May 6, 2016  
File No. 20.0154335.02

Re: Response to Great Lakes-St. Lawrence River Water Resources Regional  
Body's May 4, 2016, Preliminary Draft Declaration of Finding  
City of Waukesha Water Supply  
Waukesha, Wisconsin

**Figure 1: Historical GPCD and Trend**

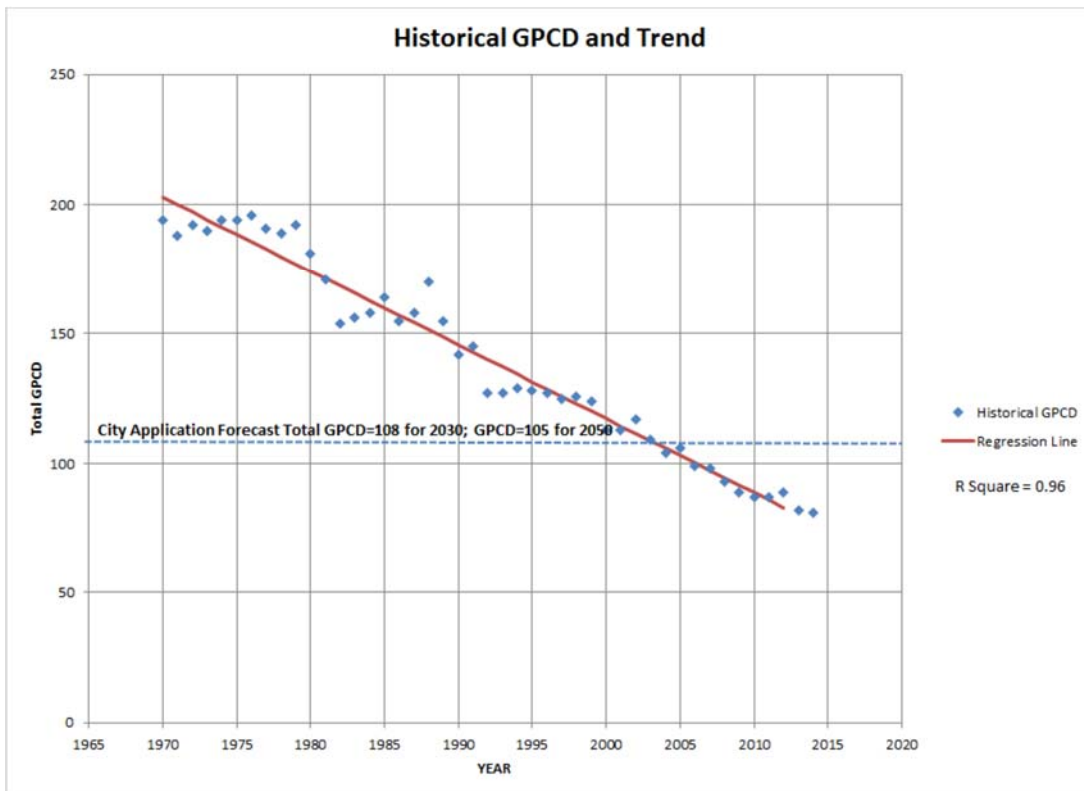
Review of the Draft Findings and AECOM’s “Water Demand Projections – Diversion Water Supply Area, Waukesha, Wisconsin” (AECOM, 2016) indicates that future water demand is revised to be 8.4 million gallons per day (MGD), of which 8.2 MGD is based on the population and industrial land acreage in the Current Served Area; 0.2 MGD of which is to serve the relatively small areas under consideration by the Regional Body to be added to the Current Served Area. It is important to note that the 8.2 MGD for the Current Served Area, the same forecast used in the City’s Application, is overestimated, as it ignores the decreasing water demand trend from 2003 to 2012, as shown in the following historical GPCD chart (GZA, 2015).

Using the average GPCD from 2008 to 2012, GZA estimated the water demand for the Current Served Area to be 6.7 MGD (GZA, 2015). By adding the difference of 0.2 MGD for the additional area, the average day demand for the Diversion Approved Area is estimated to be 6.9 MGD. This more appropriate projection of water needs is a critical point, as it allows more reasonable estimations of water treatment costs for Waukesha, drives sustainable pumping rates from the deep aquifer and less environmental impact to the Mississippi River Basin under the non-diversion solution.
